STAGE 3

Client: University of Huddersfield
Architect: N/A
Project: UOH Solar PV
City/Town: 3MBIC
Drawing Title: Electrical Schematic
Proposed PV Connection Principle

Job No.	0000000	Scale/Alt	1 : 1
Drawn By	AD	Checked By	ZA
Approved By	PD	Revised	
Drawing No.	UOH-BHE-3M-ZZ-DR-E-1100	Revision	P03

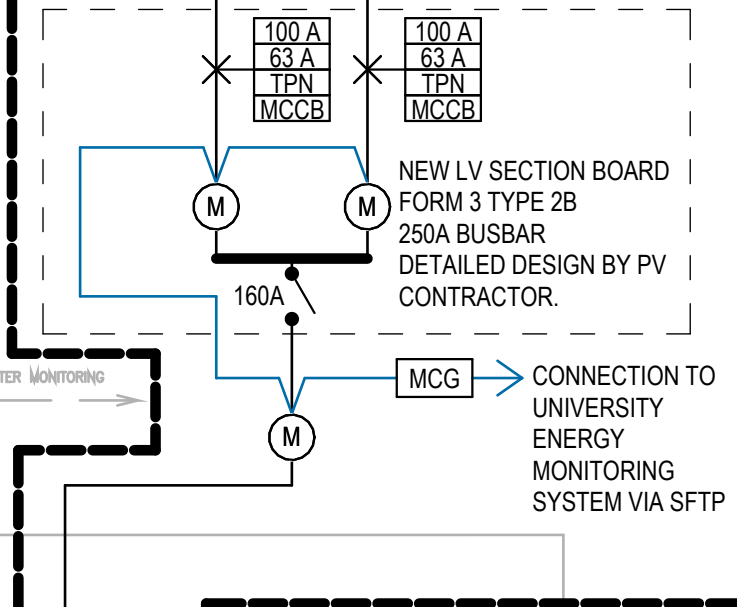
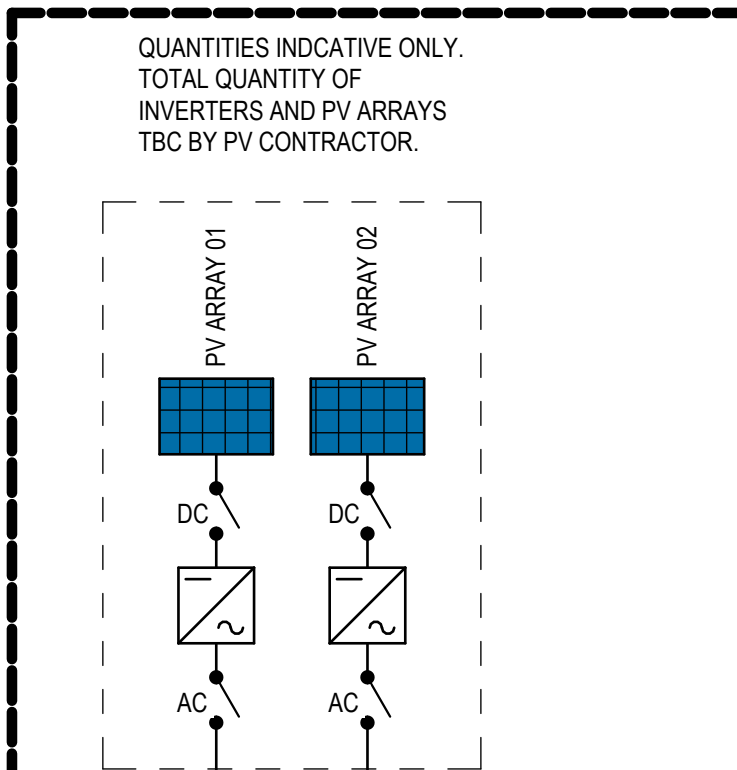
COST OPTION 1: PROVIDE NEW PV SYSTEM. PERFORM IN
ADDITION TO STRIP OUT OF EXISTING PV SYSTEM.

UTILISE EXISTING SPARE WAYS IN LV
SWITCHBOARD TO PROVIDE NEW PV
CONNECTION.
BREAKER TO BE PROVIDED WITH A LOSS OF
MAINS PROTECTION RELAY

COST OPTION 2: PROVIDE COST OF
INVERTER REPLACEMENT, TESTING AND
COMMISSIONING ONLY.

COST OPTION 1: ISOLATE AND STRIP OUT.
REDUNDANT EXISTING PHOTOVOLTAIC
SYSTEM AT END OF SERVICEABLE LIFE.
PERFORM IN CONJUNCTION WITH
PROVIDING A NEW PV SYSTEM.
